Project: Twin Hills Power System Upgrade

Solicitation No.: 19023

Addendum No. One

GENERAL – QUESTIONS & ANSWERS

1 STANDBY MODULE SITE PLAN
SCALE: 1"=10'

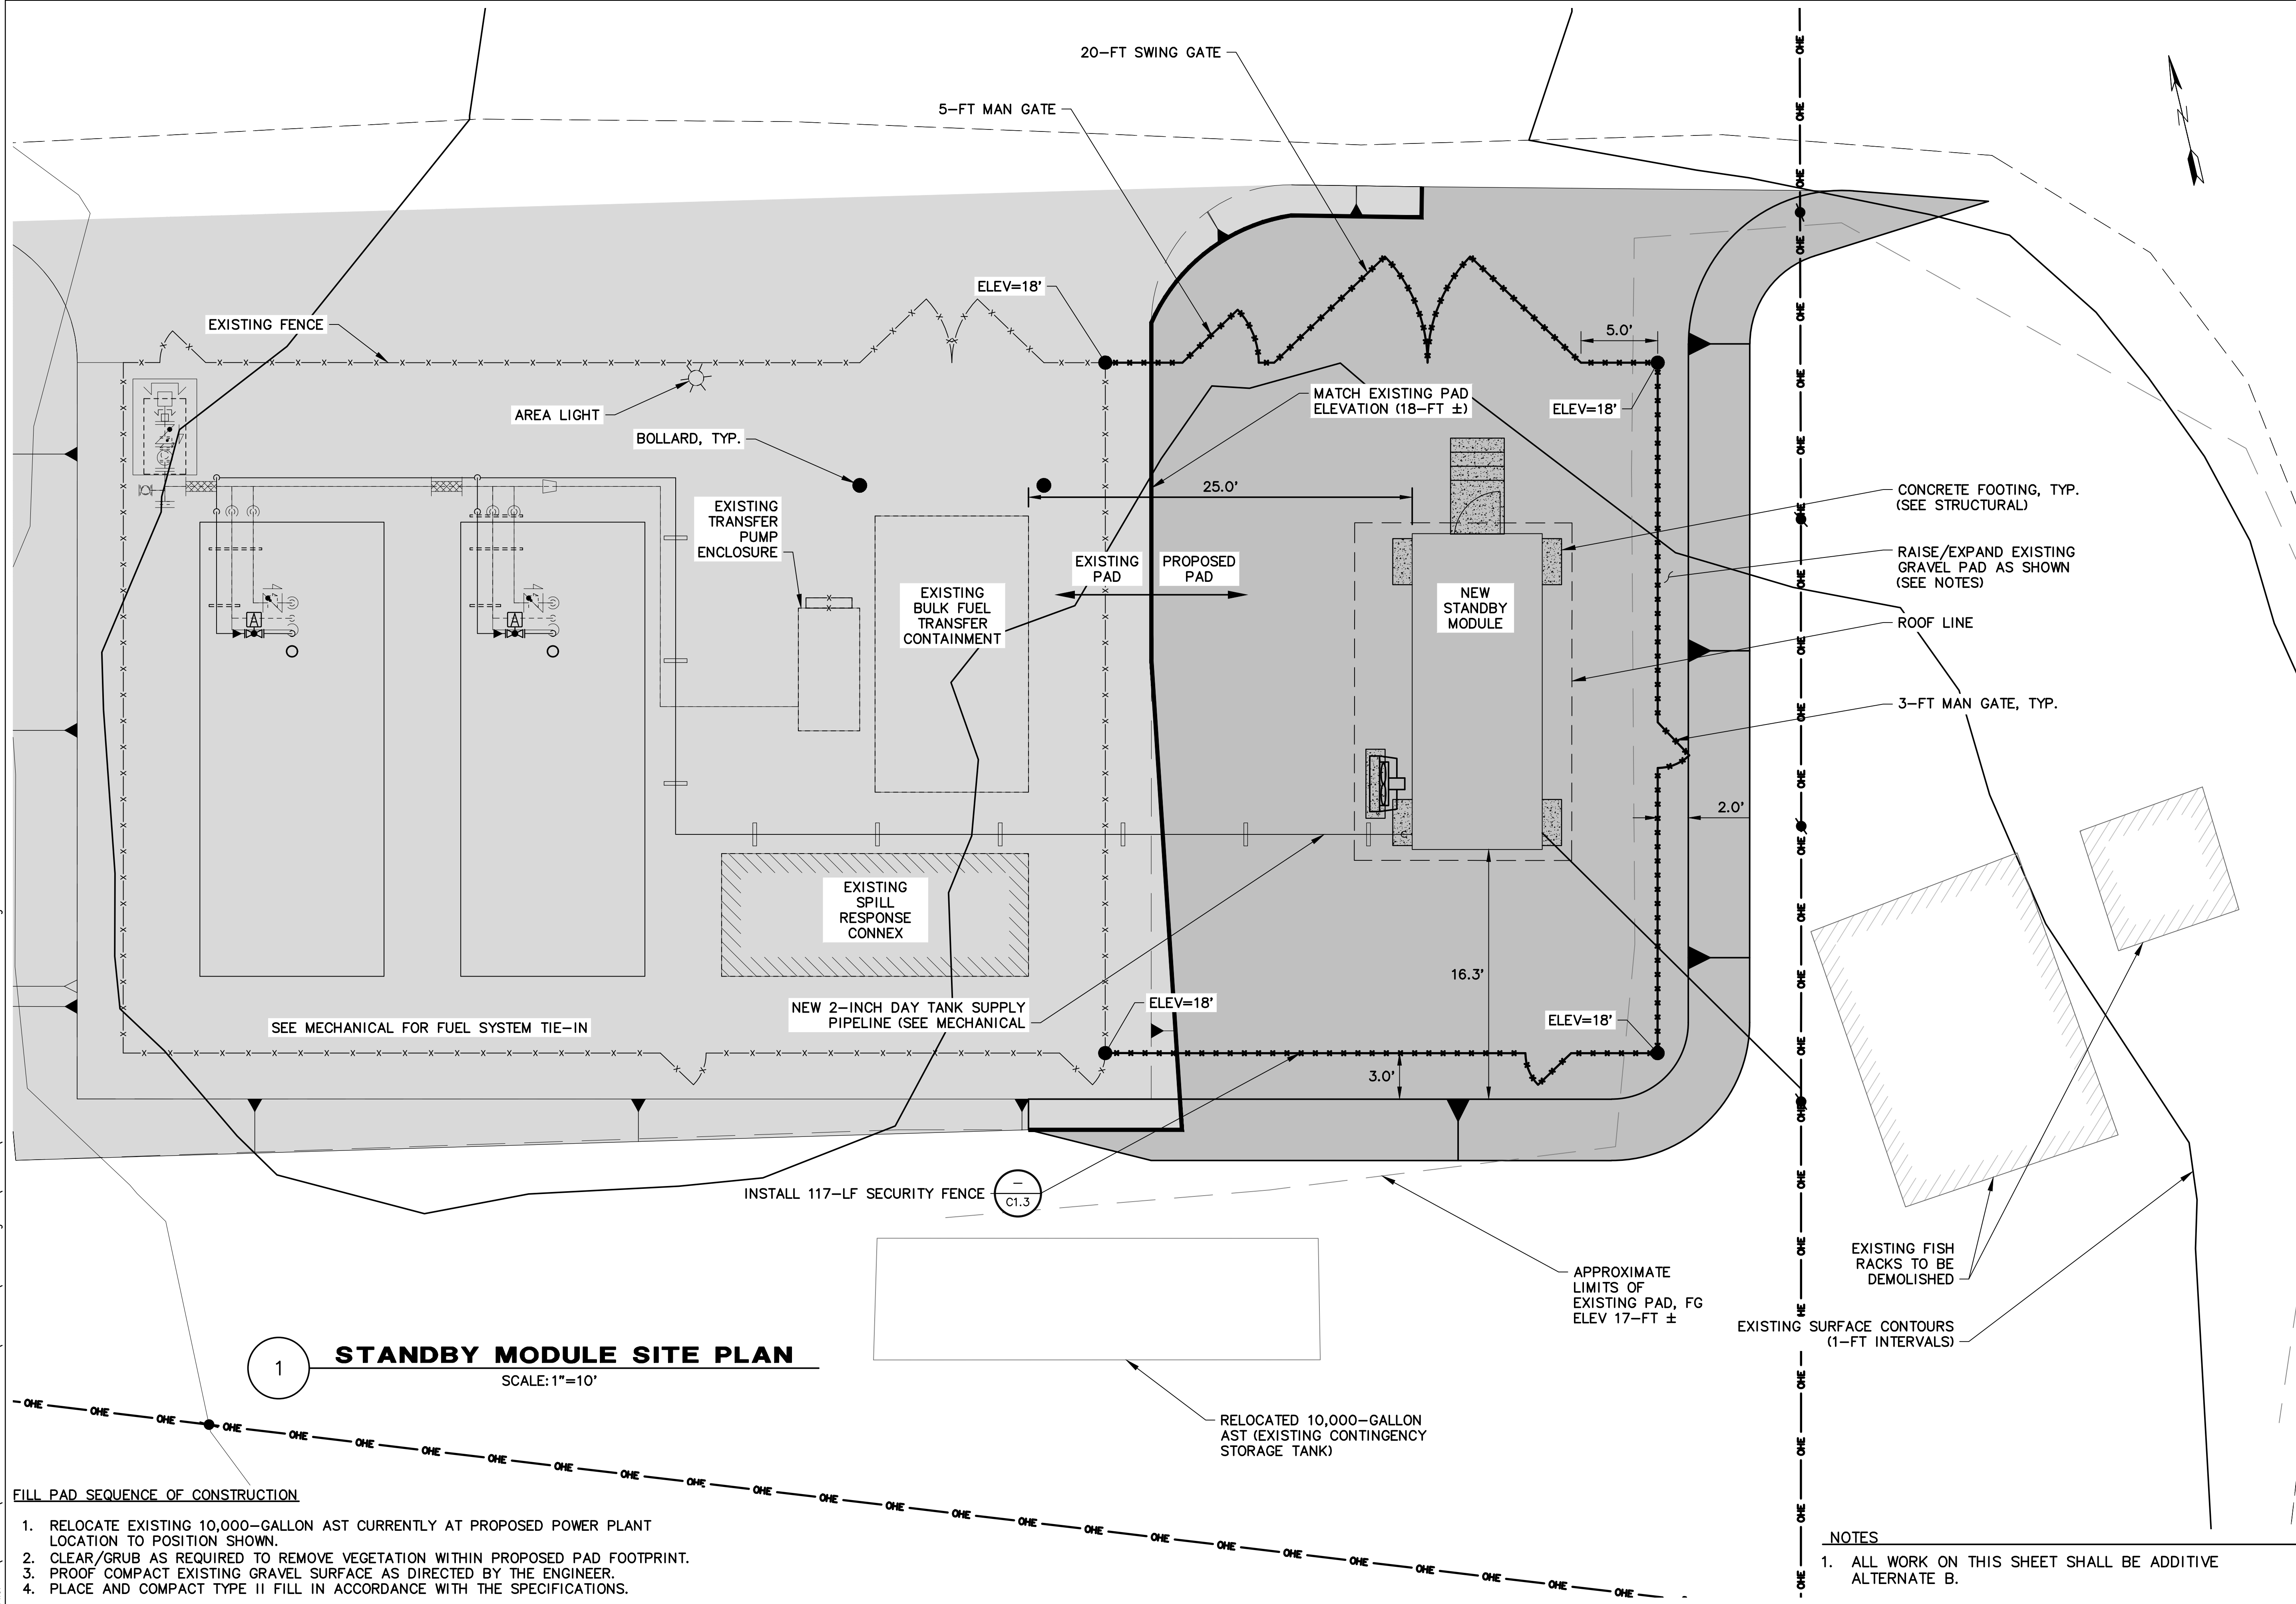
11) **Q:** Drawing C1.2 - BOLLARD, TYP. symbol does not match legend but matches corner and tie-in of new fence. Does scope include bollard install, if so, how many?

Sheet No. M3.1

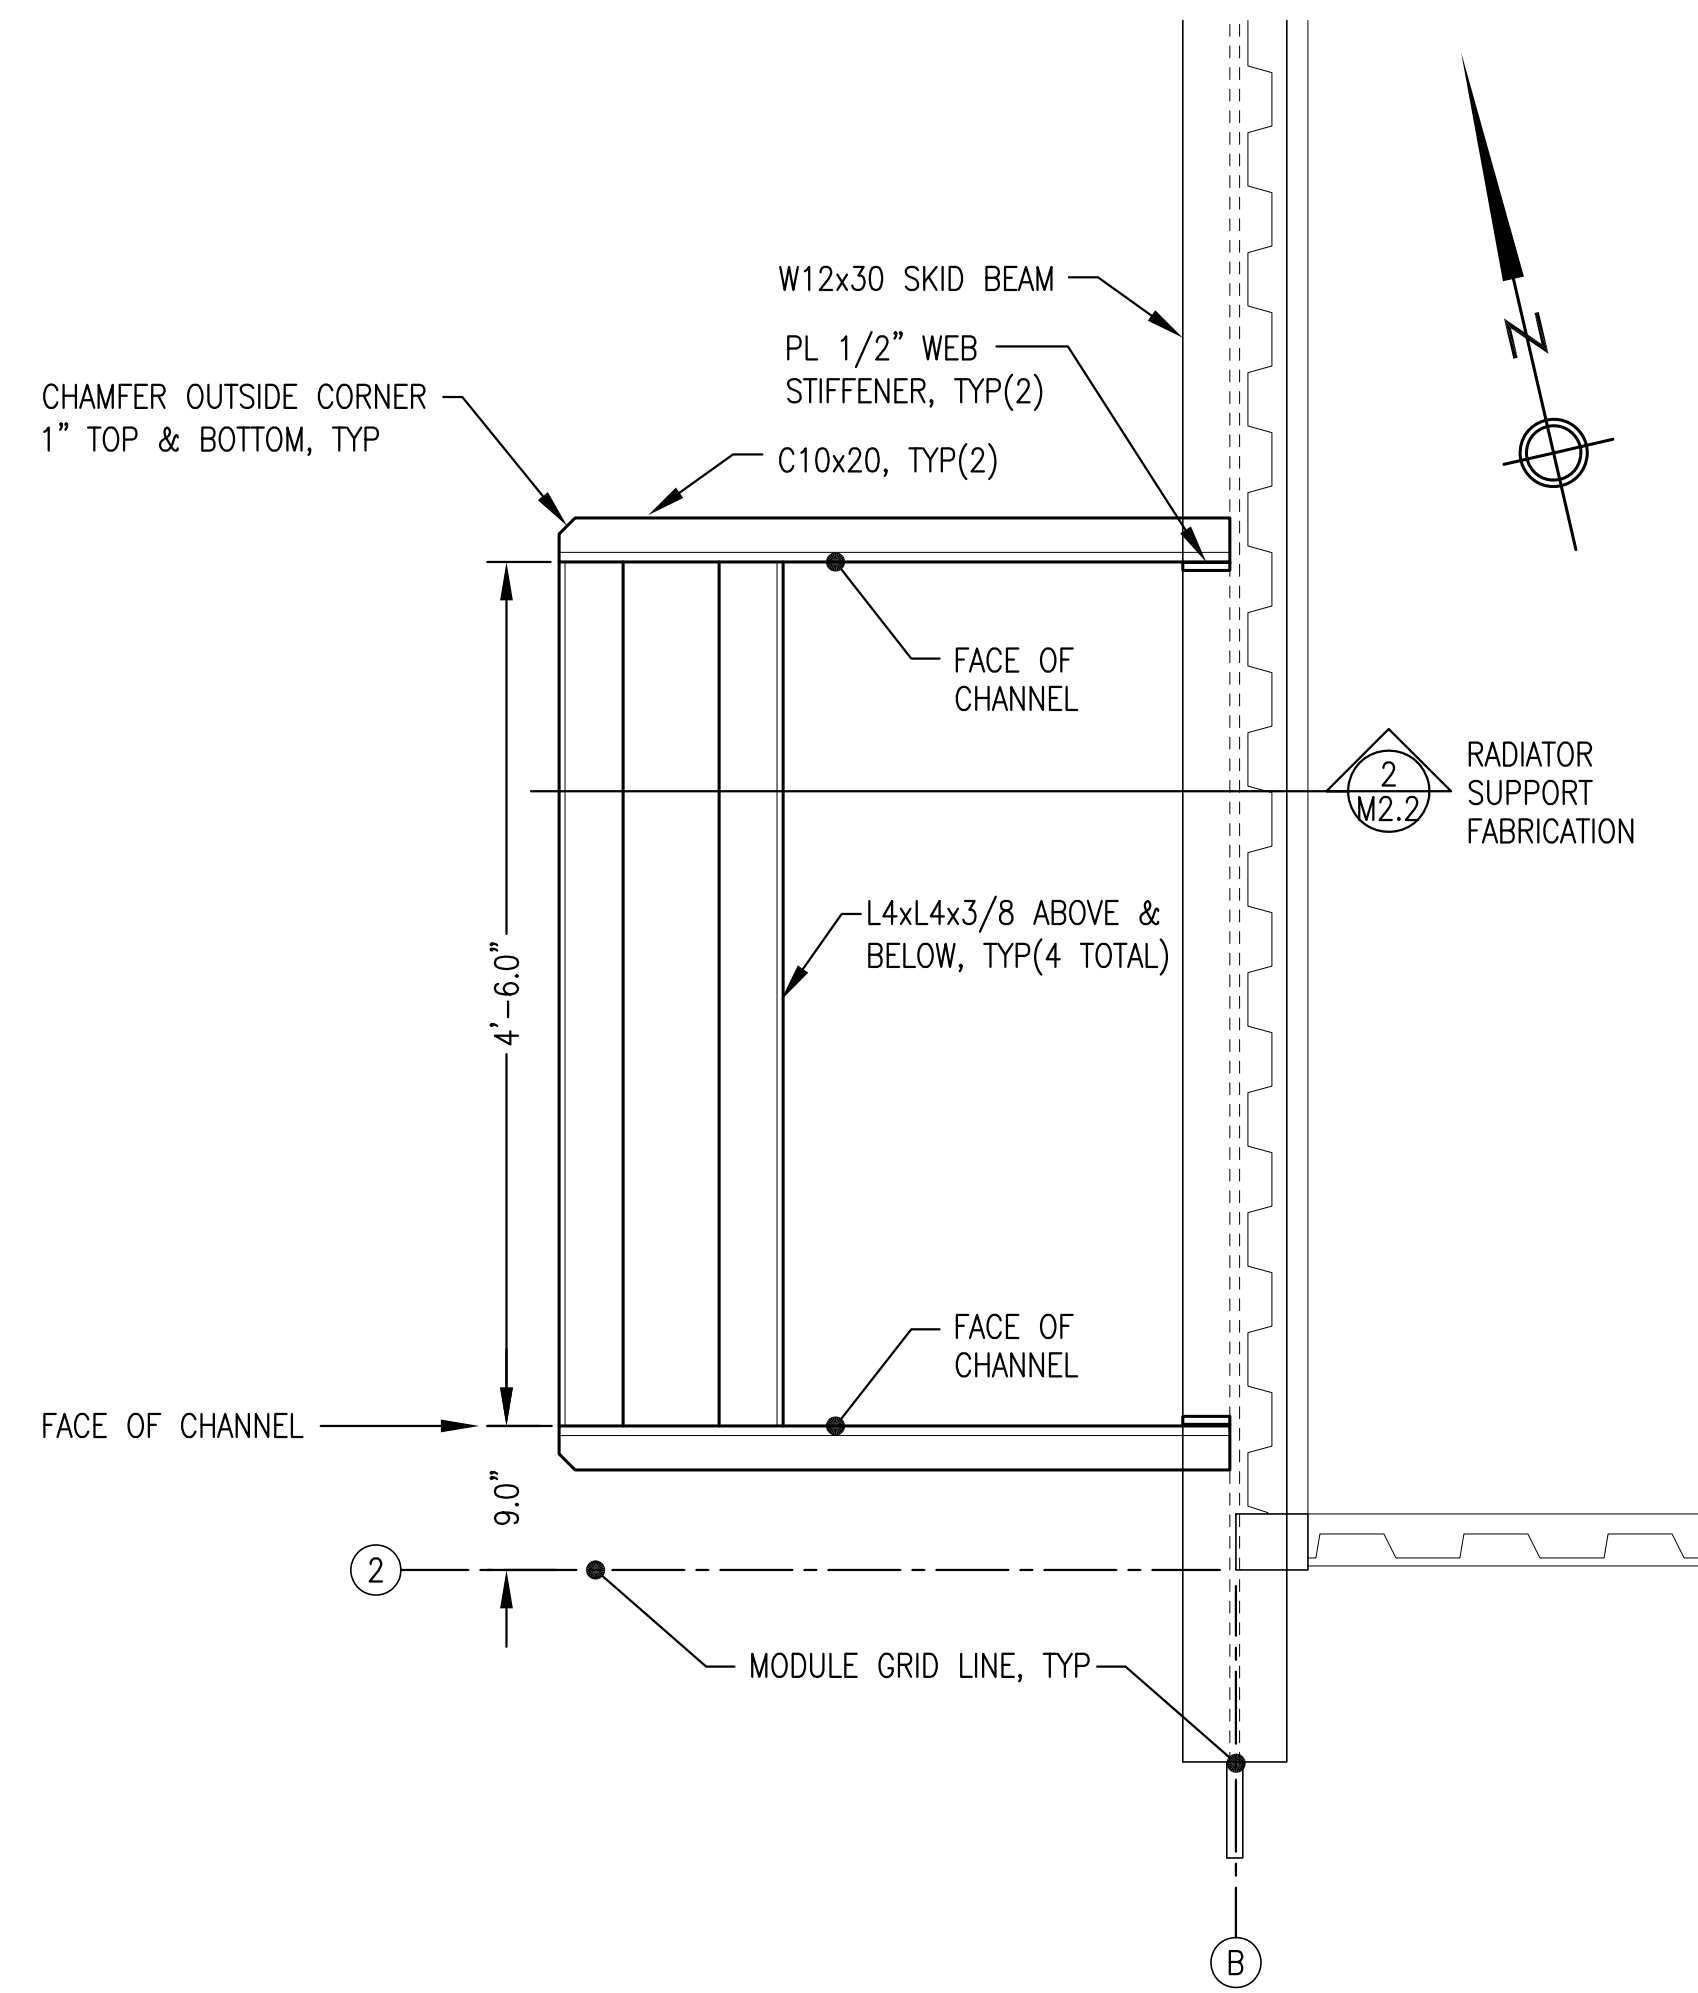
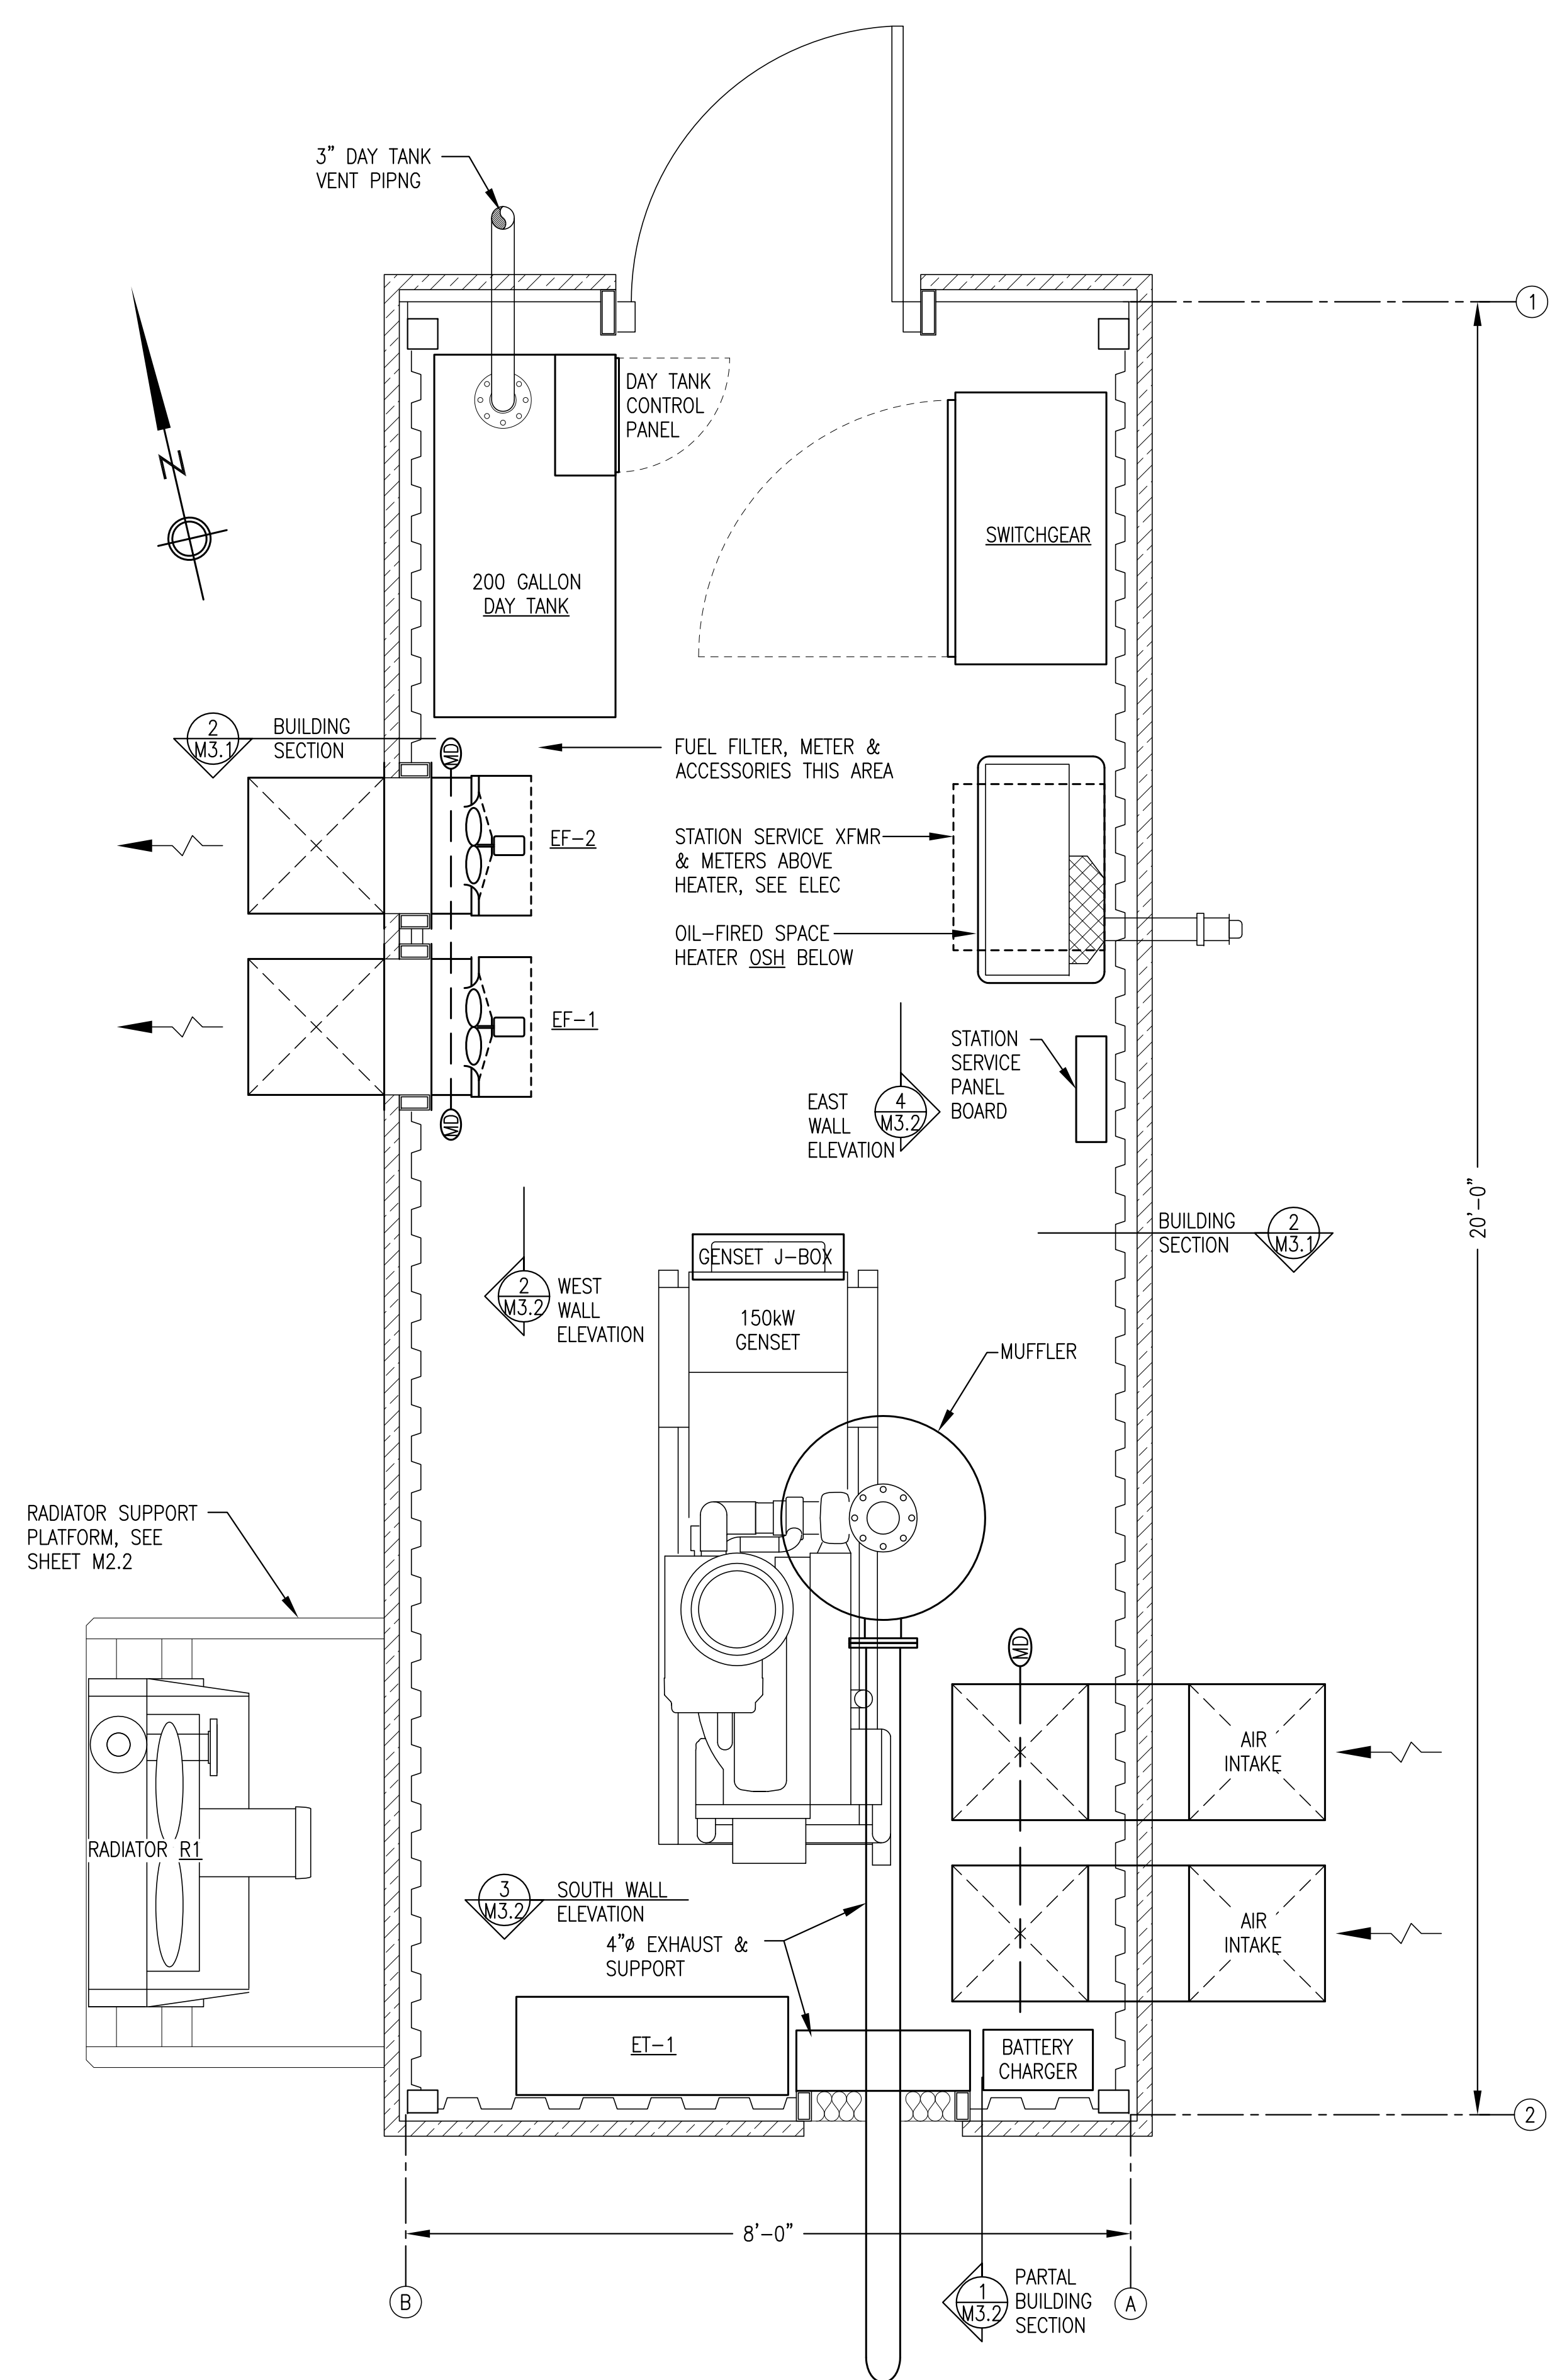
12) **Q:** Discrepancy in drawing S1 & M3.1 for the radiator support; S1 detail 1 indicates a concrete foundation and M3.1 displays a mod mounted foundation. Is S1 incorrect?

A: The radiator support from the skid shown on Sheets M2.2 and M3.1 is correct. Delete the radiator support concrete pad shown on sheet S1.
